MI CR 3

Application Type: New Right-of-Way Pipeline

Assigned Right-of-Way Number: OCS-G26866

Assigned Segment Number: 15170

GSF Arctic I Mooring Pattern

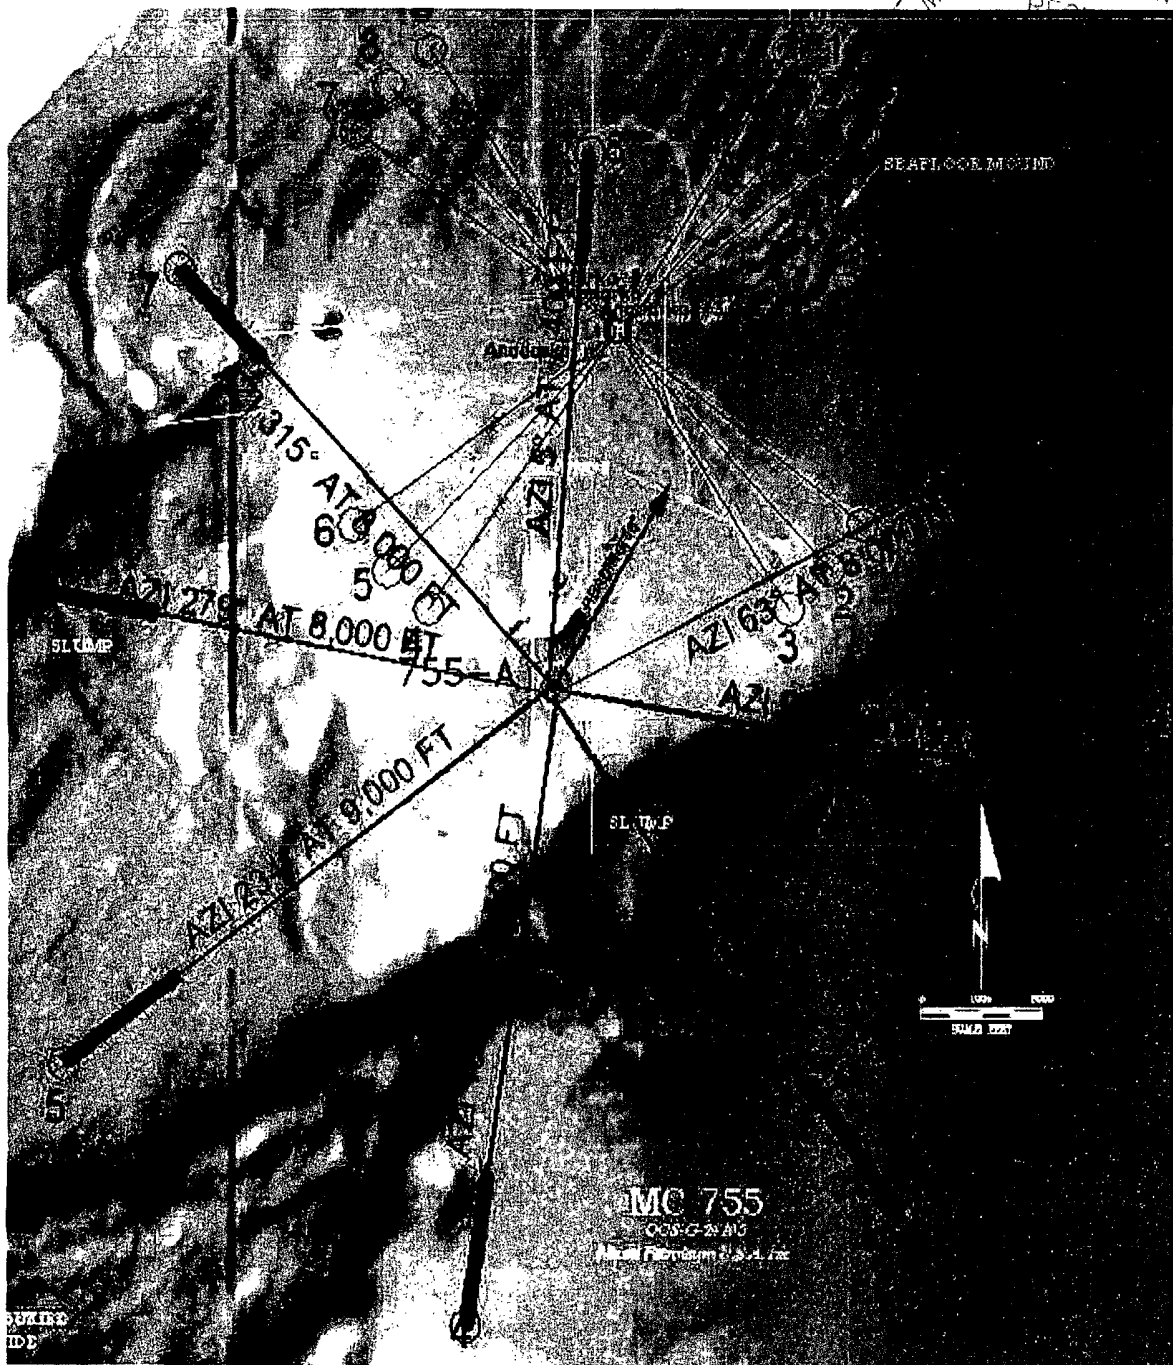
Additionally, Nexen has submitted in their Revised Exploration Plan to drill MC 755 Well No. 3, a proposed mooring arrangement for the "GSF Arctic I" which poses potential conflicts associated with the ATP flowline and umbilical installation proposal. In letters dated June 2, 2005 and June 20, 2005, signed by Larry McRae of Nexen, it was requested that the MMS not approve ATP's proposed plans until both companies could discuss these conflicts.

evaluated and it is our intent to work towards a win-win solution for both parties. This will require considerable effort and cooperation from both parties and will include reduction of safe zones and careful SIMOPs planning. We have included a proposed mooring arrangement for the "GSF Arctic I" which illustrates the potential conflicts associated with the flowline and umbilical installation.
